AGENDA - LPP

Meeting:	Georges River Local Planning Panel (LPP)
Date:	Thursday, 17 June 2021
Time:	4.00pm
Venue:	Council Chambers, Civic Centre, Hurstville
Panel Members:	Paul Vergotis (Chairperson) Milan Marecic (Expert Panel Member) Michael Leavey (Expert Panel Member) Erin Sellers (Community Representative)

**REPORT TO GEORGES RIVER COUNCIL
LPP MEETING OF THURSDAY, 17 JUNE 2021**

LPP Report No	LPP026-21	Development Application No	DA2020/0236
Site Address & Ward Locality	206-214 Railway Parade Kogarah Kogarah Bay Ward		
Proposed Development	Demolition works, lot consolidation, site preparation and construction of a twelve (12) storey mixed use development containing ground floor and first floor commercial floor space and 49 residential apartments above three (3) levels of basement containing 75 car spaces, level 1 and roof top communal open space, landscaping and site works		
Owners	Kyser Pty Limited		
Applicant	Novakog Pty Ltd ATF Novakog Trust		
Planner/Architect	Planner: City Plan Architect: Fuse Architects		
Date Of Lodgement	12/06/2020		
Submissions	Twelve (12) submissions		
Cost of Works	\$18,570,935.00		
Local Planning Panel Criteria	The application seeks consent for dev

Figure 13: Section showing extent of non-compliance to height control.

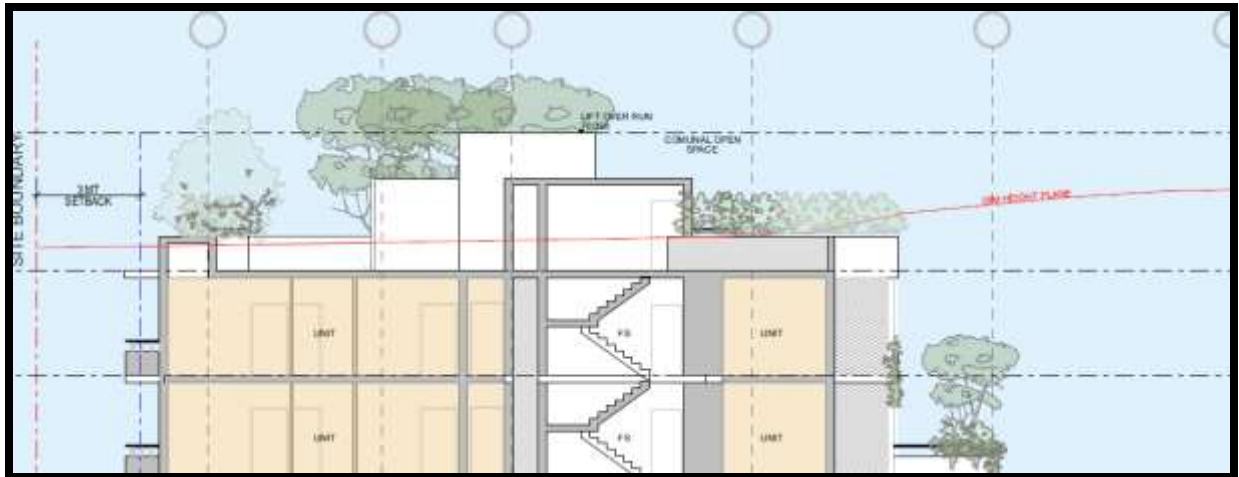
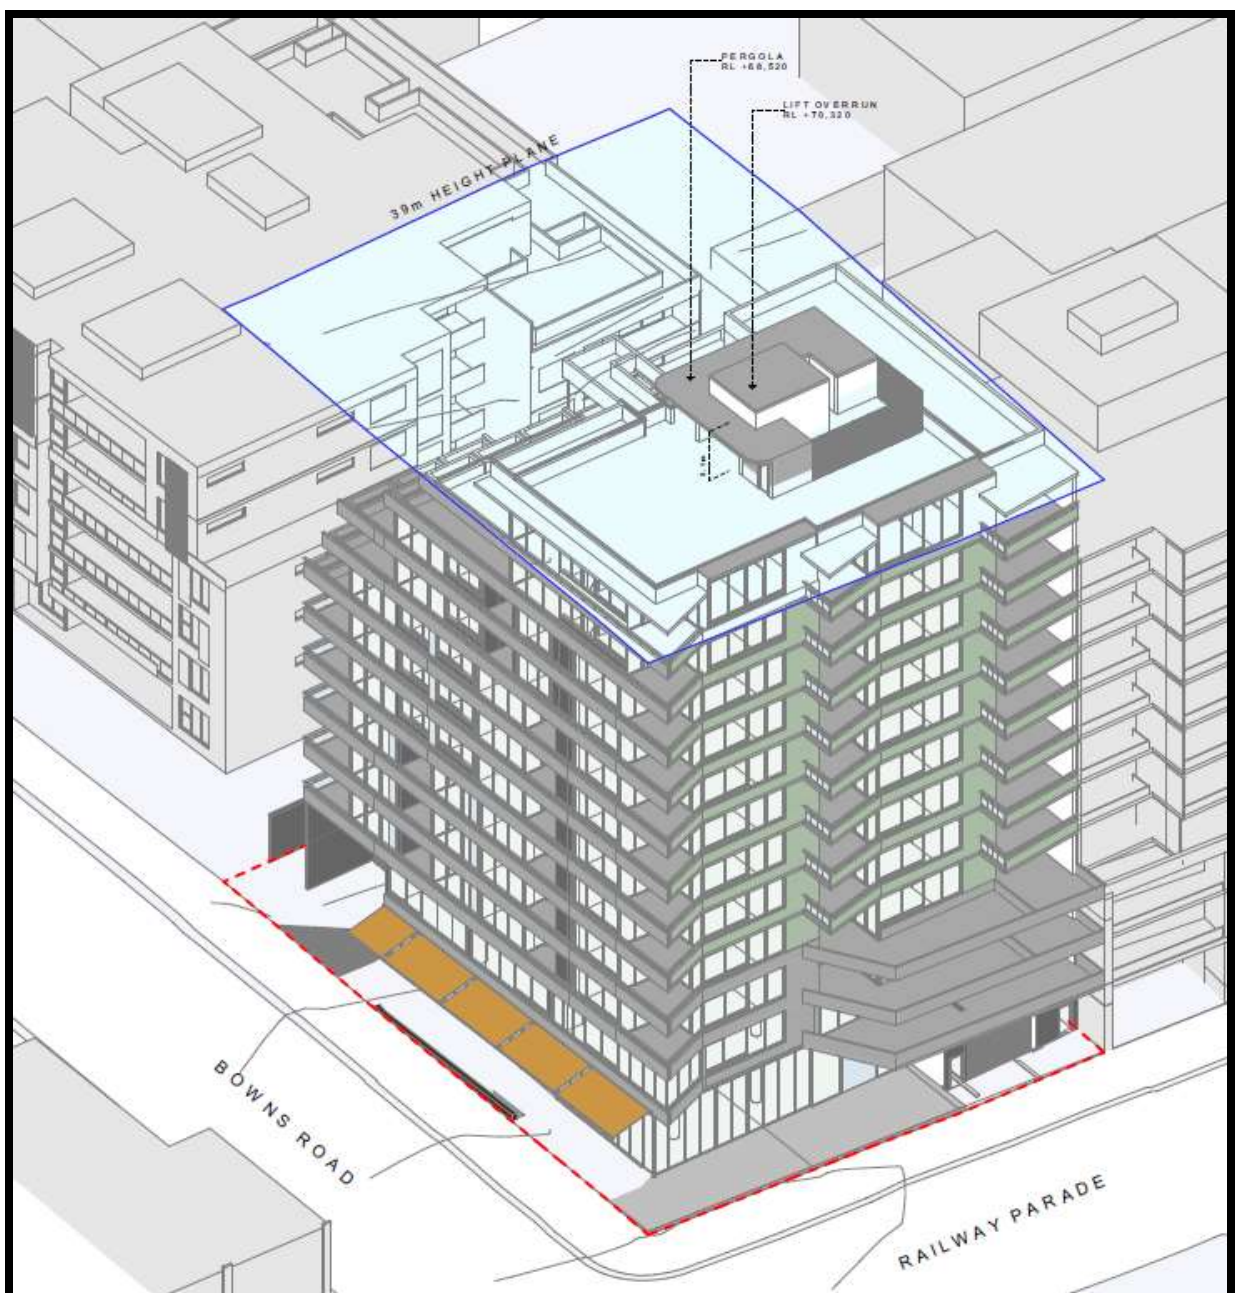
87. The location and extent of the non-compliance is provided in the images below (figures 13 and 14).

88. The proposed development seeks a variation to the development standard relating to height (Clause 4.3). The KLEP identifies a maximum height of 39m for the site and the proposed development will exceed the height by 3.1m. The height breach relates to the lift over run, fire stairs and associated services having a maximum RL of 70.32m, resulting in a 7.95% variation of the control.

Figure 15: Shadow diagrams comparing shadowing from compliant to non-compliant scheme.

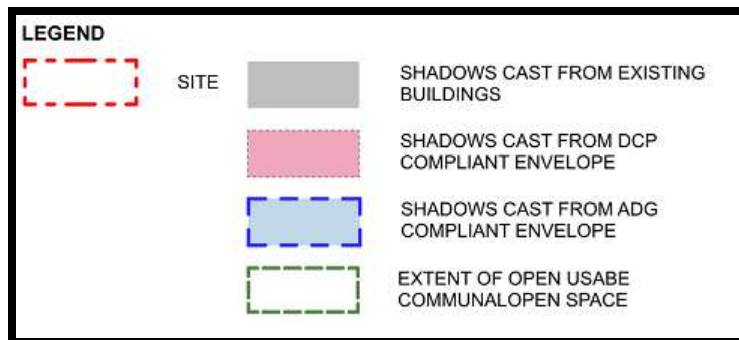
109. *The revised shadow diagrams demonstrate that the elements which contravene the height standard do not substantially increase overshadowing to surrounding sites. The shadows cast by the development have been centrally located on the roof top floorplate and will result in additional overshadowing being located within the roof of the proposal.*

110. *The amended roof top elements result in a revised shadow at 12pm. Refer to the table below.*

111. As shown above, there will be partial overshadowing of an existing carport (in blue, above) for 1 hour at 12pm during mid-winter, due to the revised roof top elements.
112. The shadow will not fall onto habitable space nor will it fall onto communal open space.
113. The revised roof top elements have been designed to provide access and amenity to future residents of the building and have been centrally located away from lot boundaries. Any overshadowing, visual, and privacy impacts have been minimised by limiting shadows to non-habitable and non-recreational spaces of 4 Blake Street, and the central

Figure 10: The extent of variation is shown in the Section (Source: Loucas Architects)

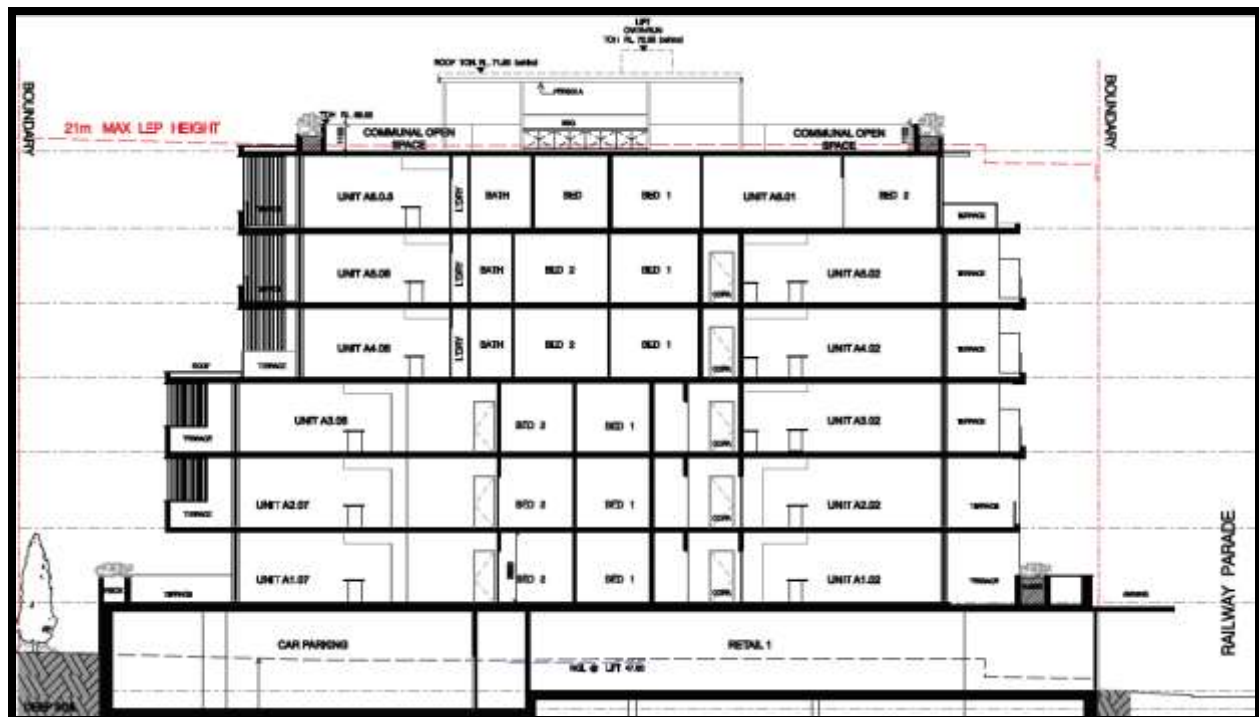
111. The proposed development seeks a variation to the development standard relating to height (Clause 4.3). The KLEP identifies a maximum height of 21m for the site (refer to Figure 11 below) and the proposed development will exceed the height by 3.95m. The height breach relates to the lift over run., fire stairs and associated services having a maximum RL 72.55m resulting in a 19.3% variation of the control. The location and extent of the non-compliance is provided in the section below.
